## Addendum No. 2

DATE:	Monday, June 24, 2019
PROJECT:	City of Pharr/PSJA Aquatic Facility
PROJECT NO:	971805/ 1819-35-510-C011-051
LOCATION:	3001 N. Cage Blvd., Pharr, Texas 78577
FROM:	Laura N. Warren, The Warren Group Architects, Inc.

A4.31 ADD2 ENLARGED STAIRWAY PLANS

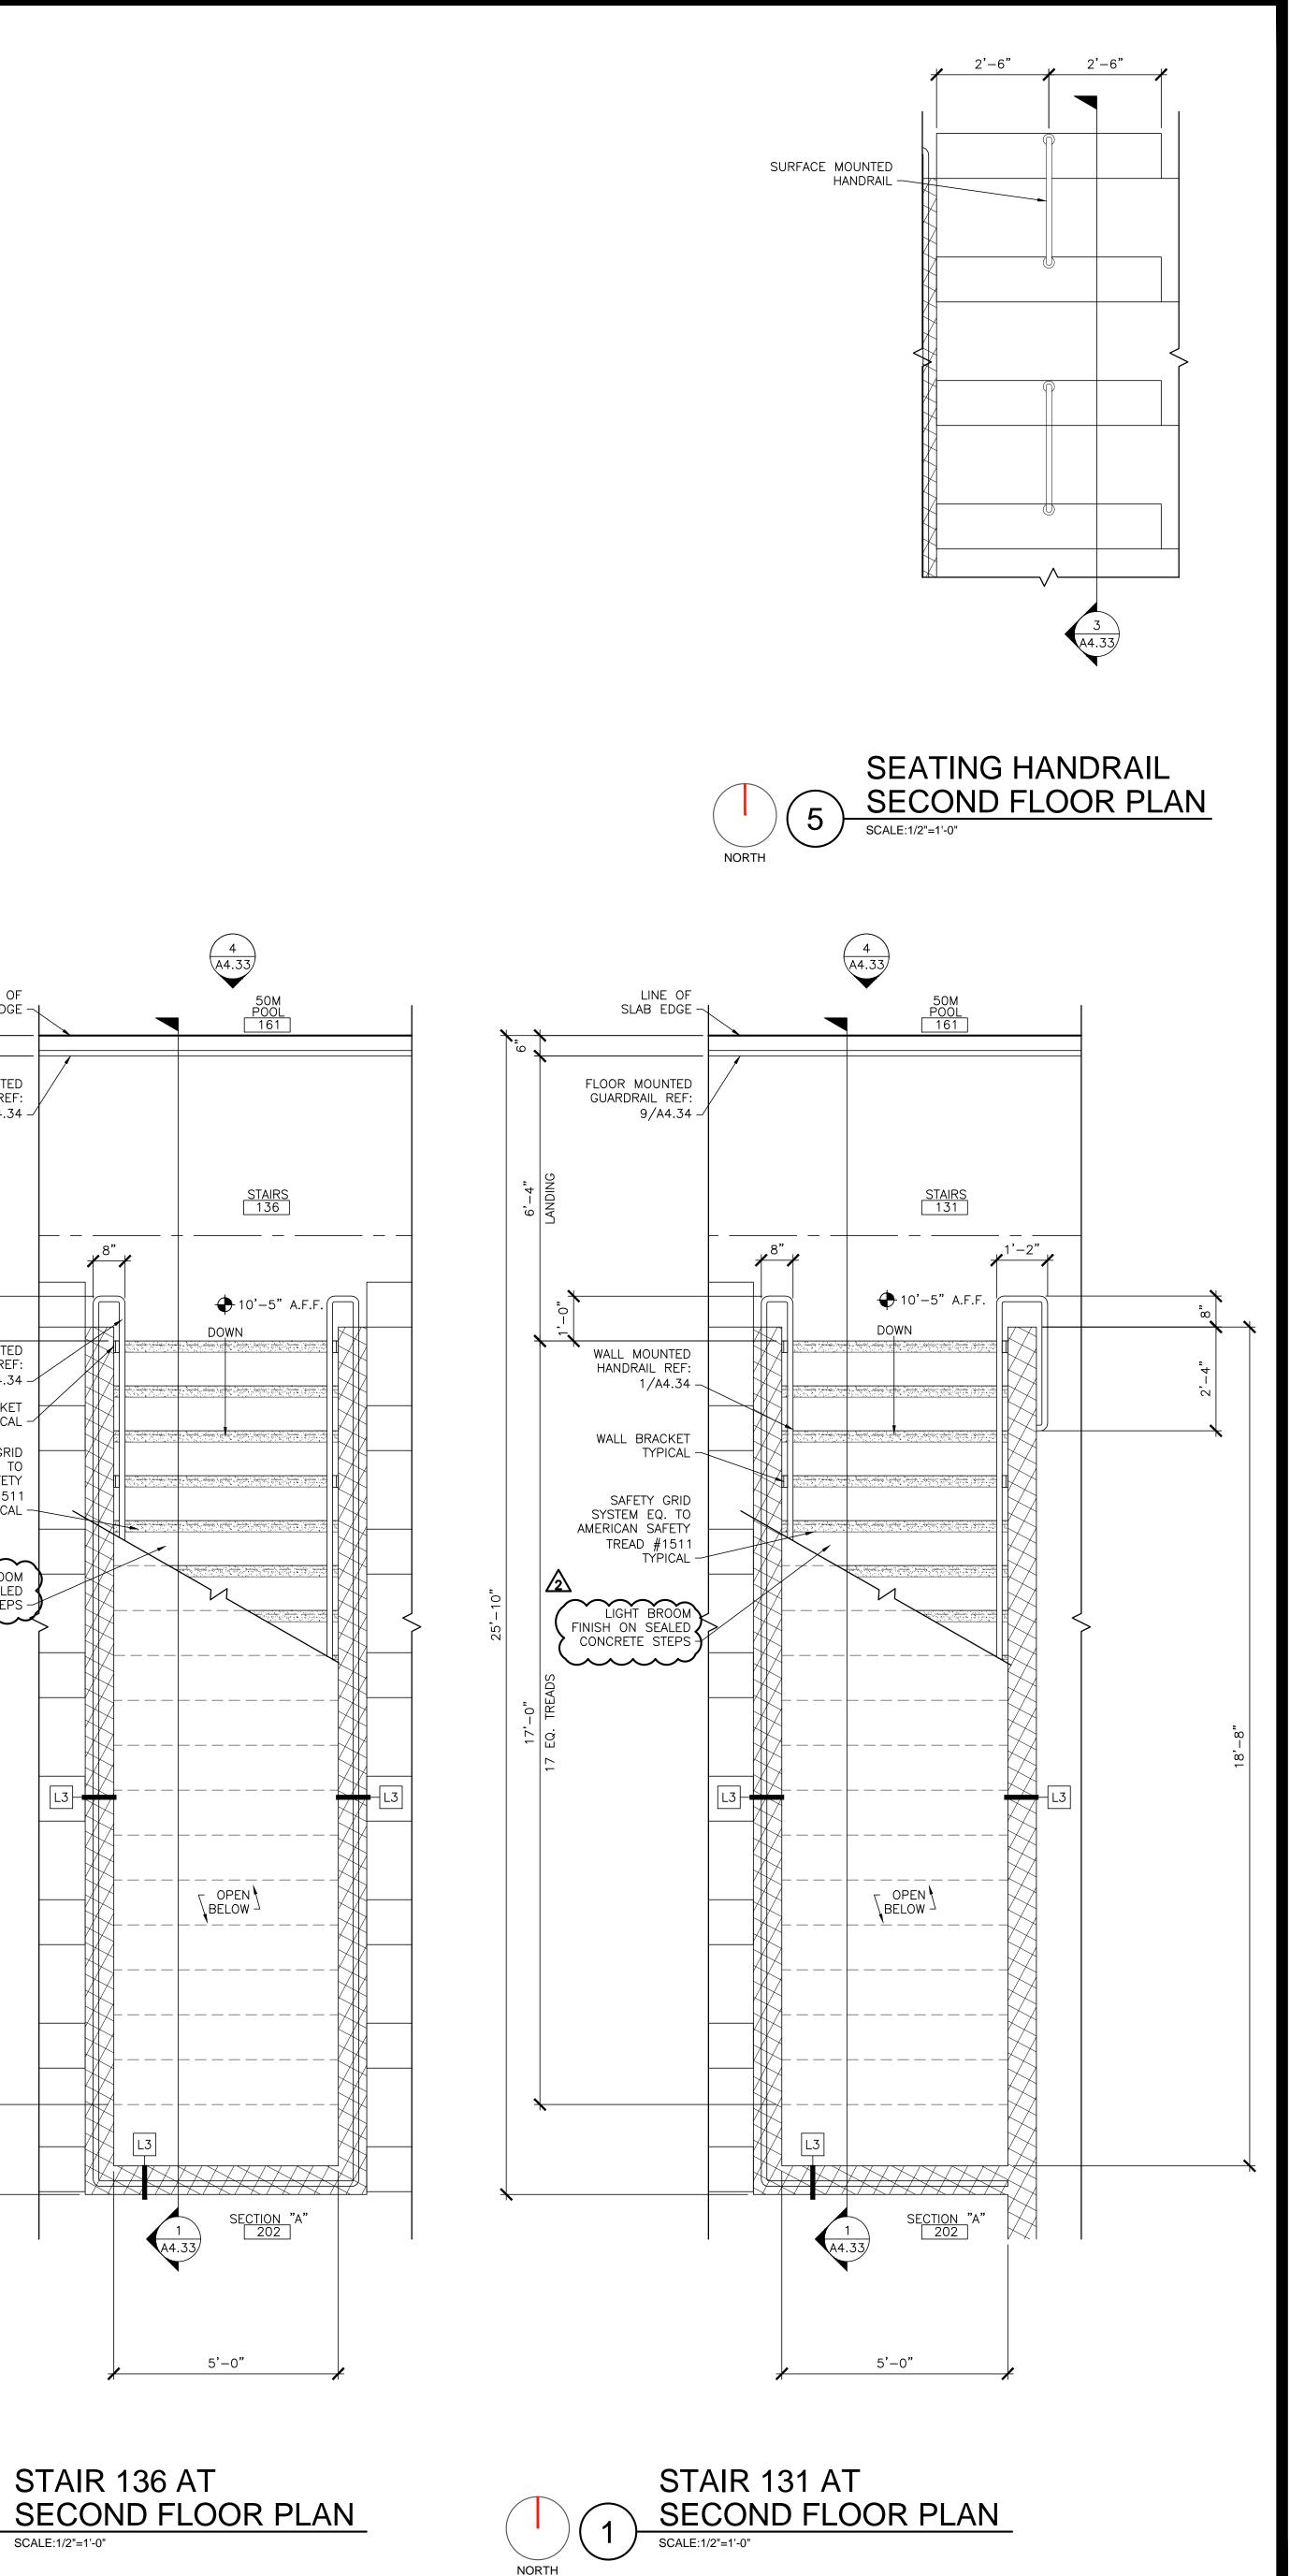
- Item No. 28: Refer to Construction Documents dated June 7, 2019. Additional sheet has been created. Refer to 30x42 sheet A4.13 ADD2 dated 6/21/2019.
- Item No. 29: Refer to Construction Documents dated June 7, 2019. Additional information has been created. Refer to 30x42 sheets A4.31, A4.32, and A4.33 ADD2 dated 6/21/2019.

A6.01 ADD2 WALL TYPES

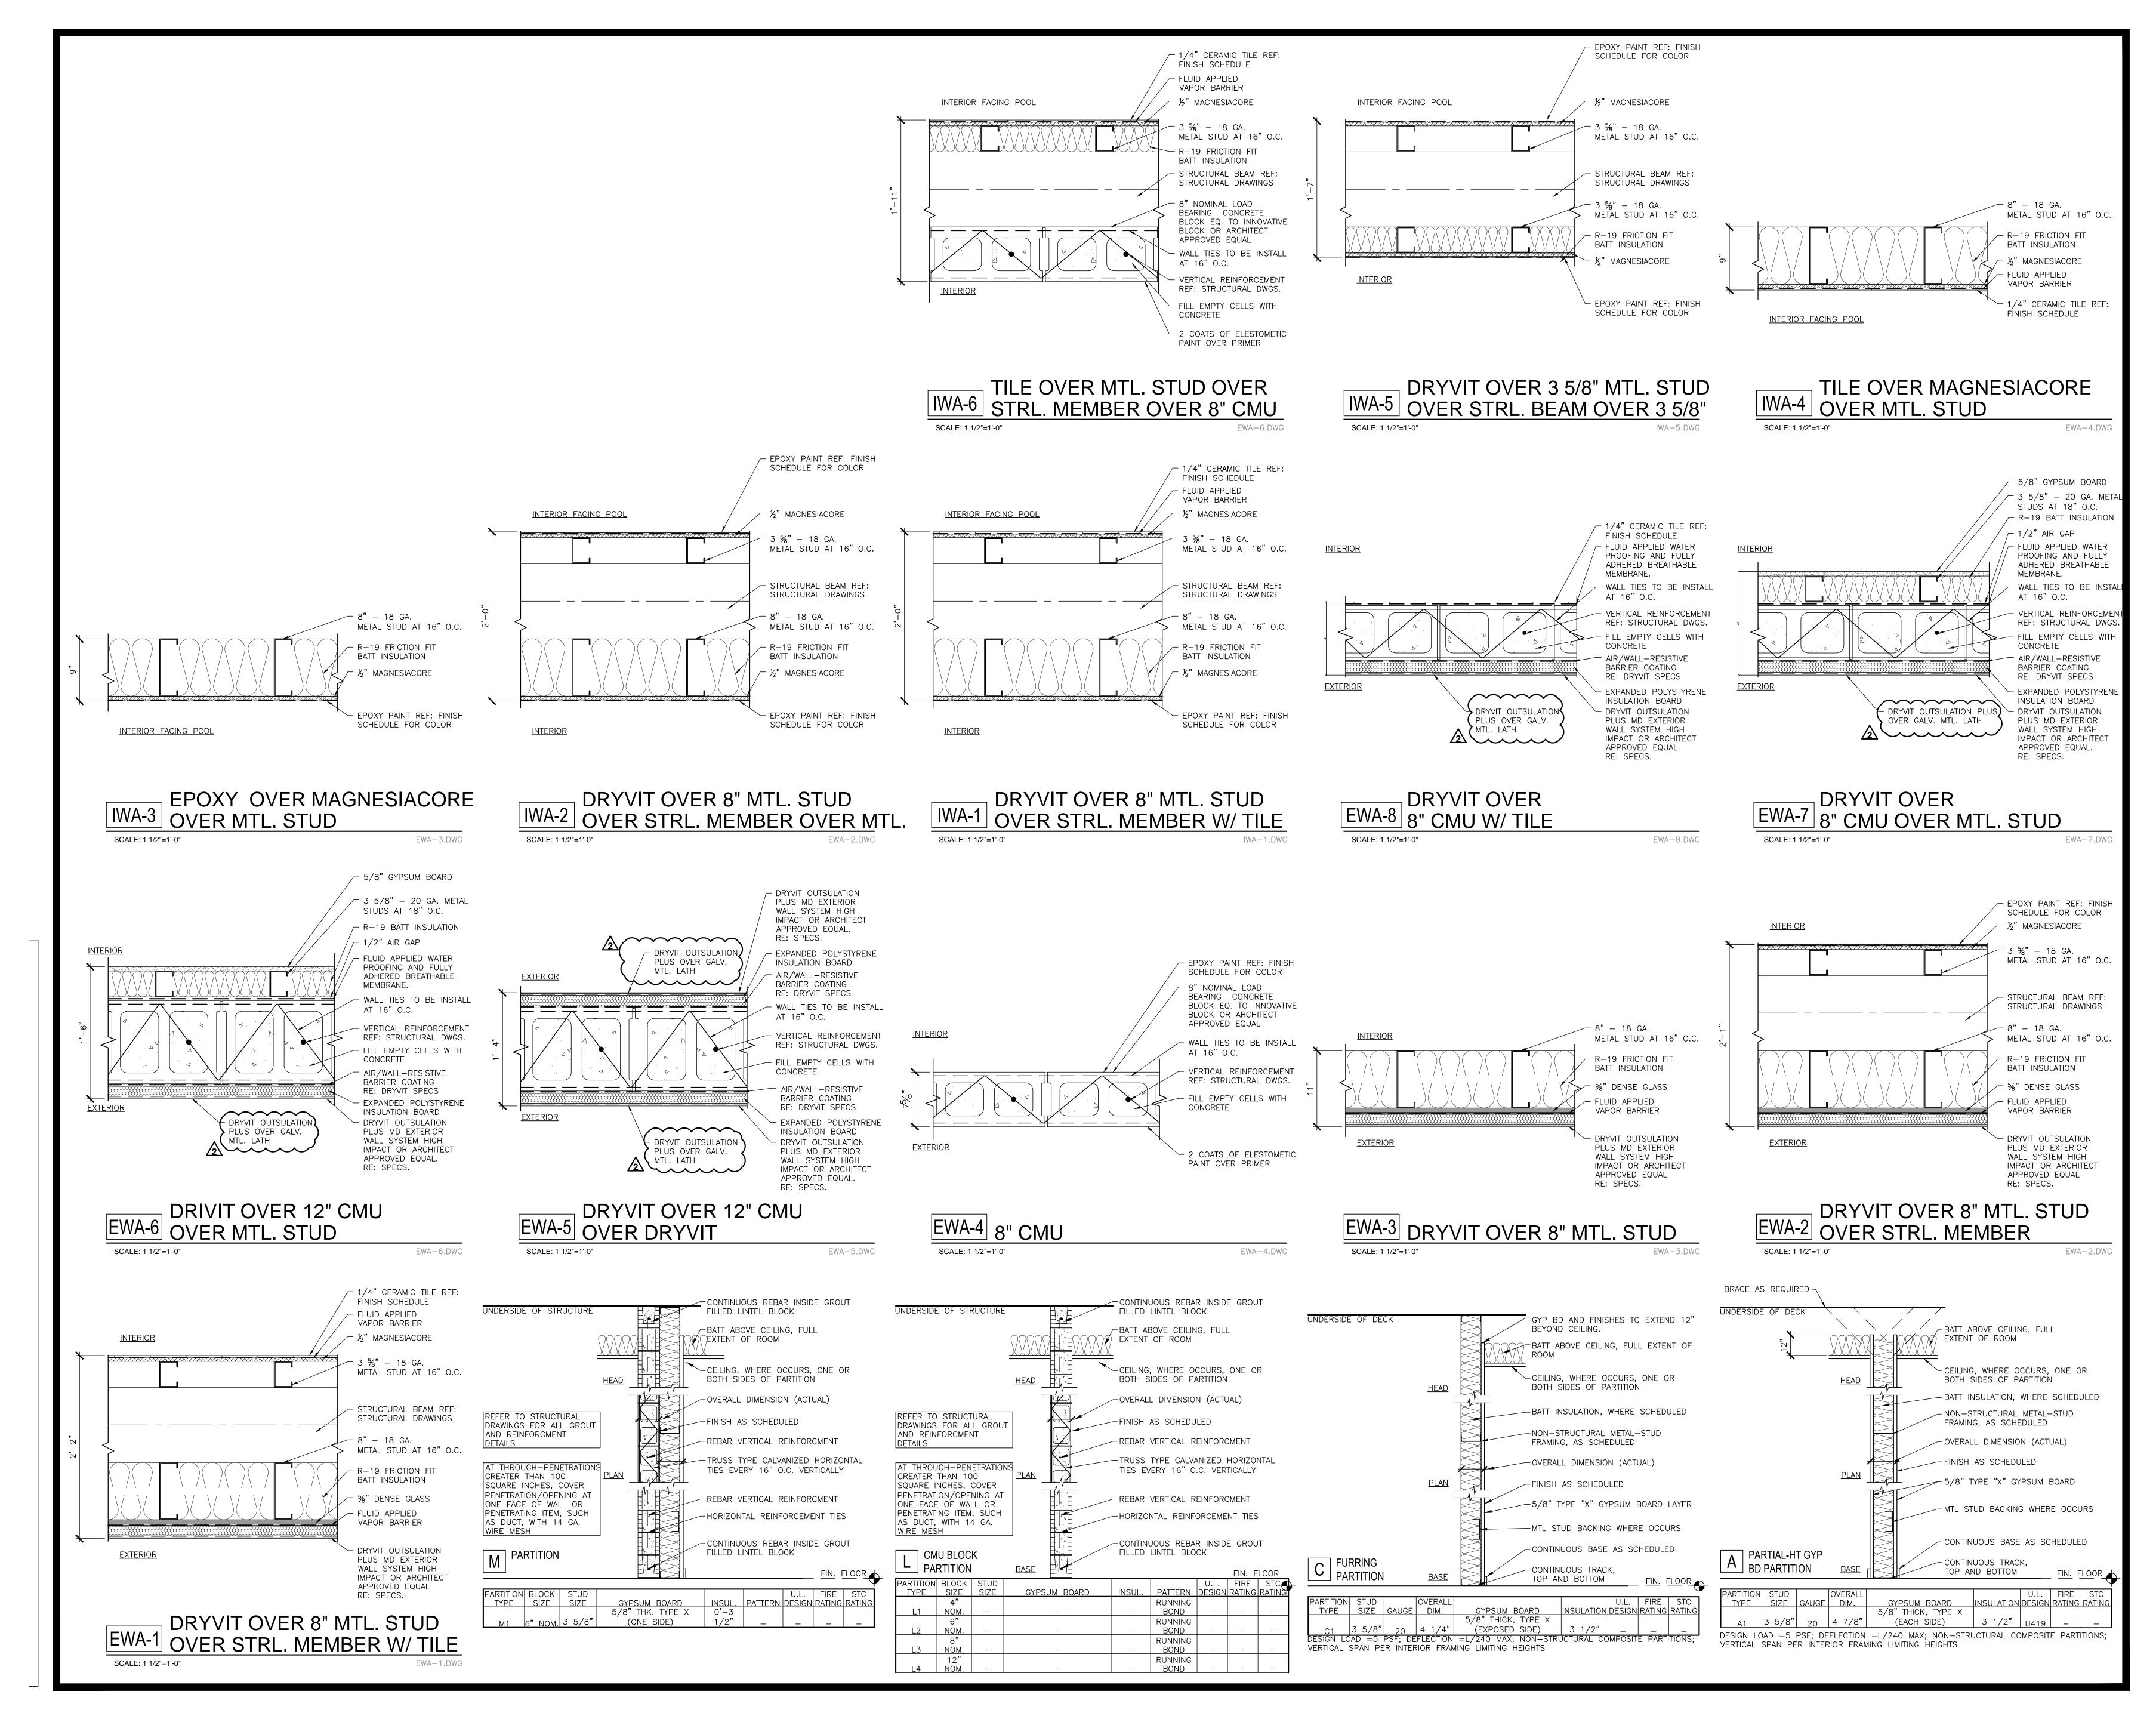
- Item No. 32: Refer to Construction Documents dated June 7, 2019. Information has been corrected. Refer to 30x42 sheet A6.01 ADD2 dated 6/21/2019.
- Item No. 33: Refer to Construction Documents dated June 7, 2019. MEP Site Plan details have been modified. Refer to 30x42 sheet M1.00 ADD2 dated 6/21/2019.

P1.02

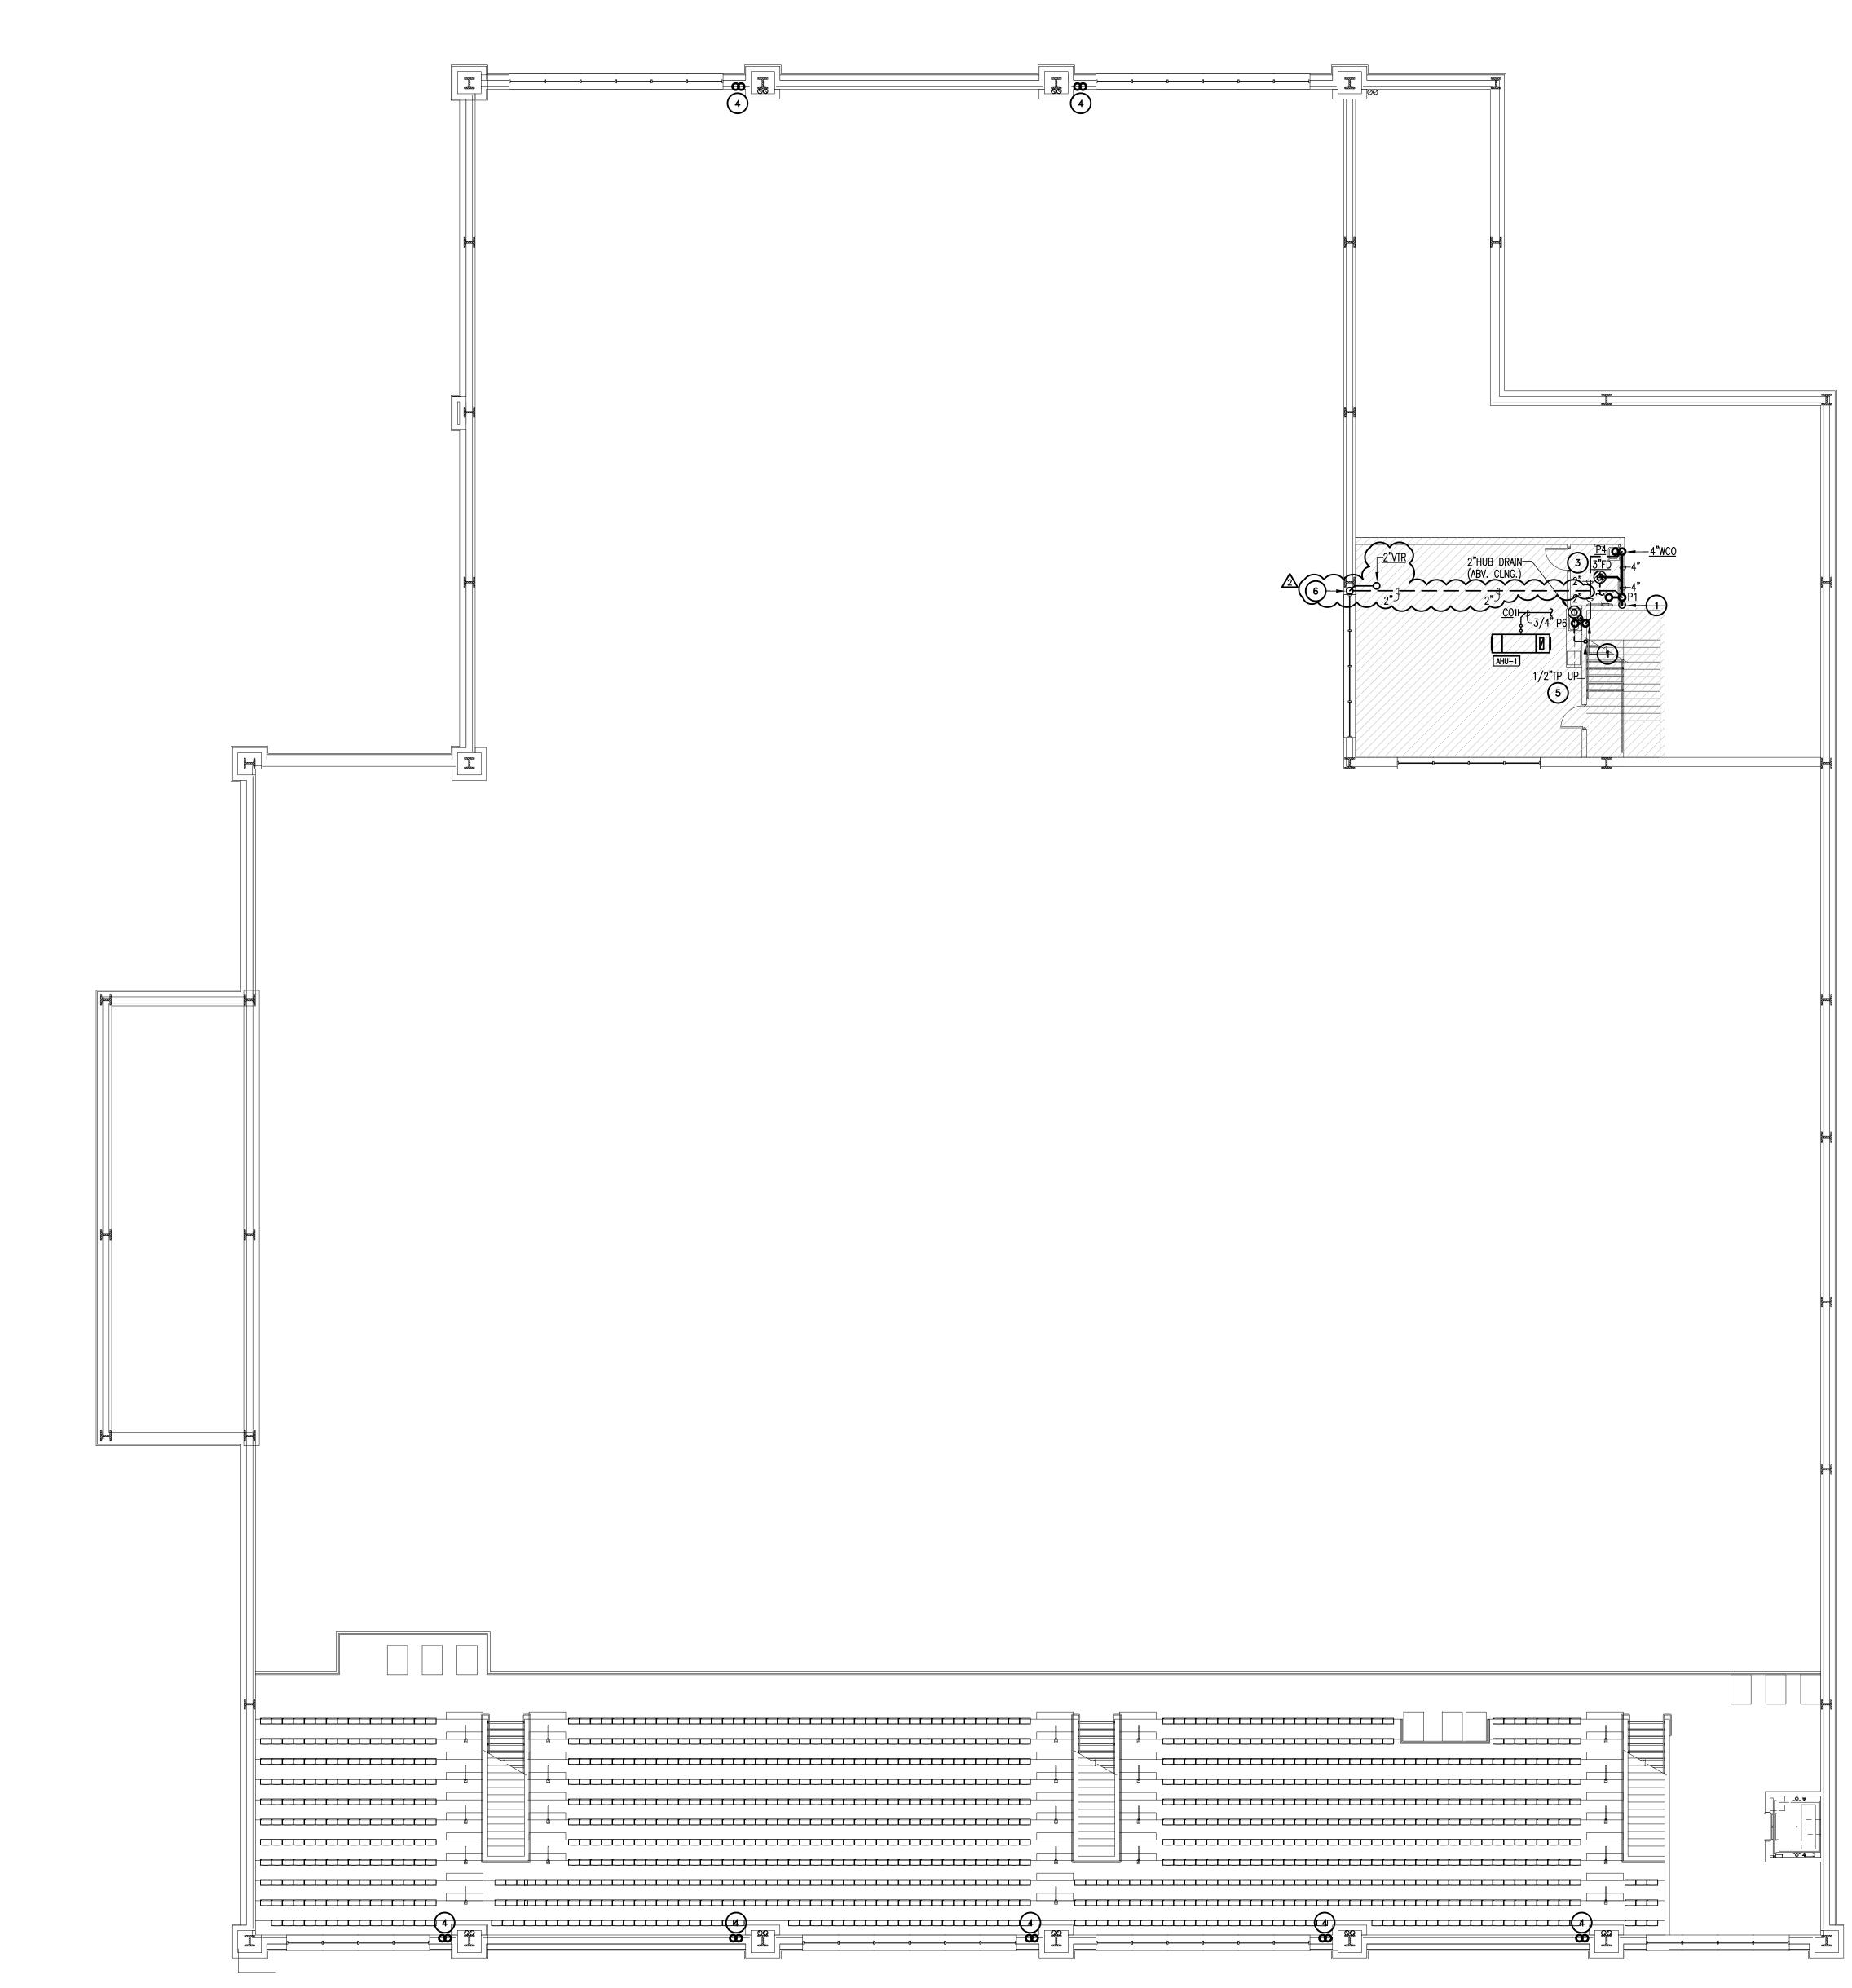
- Item No. 37: Refer to Construction Documents dated June 7, 2019. MEP Plumbing HW/CW floor plan has additional information included. Refer to 30x42 sheet P1.02 ADD2 dated 6/21/2019.
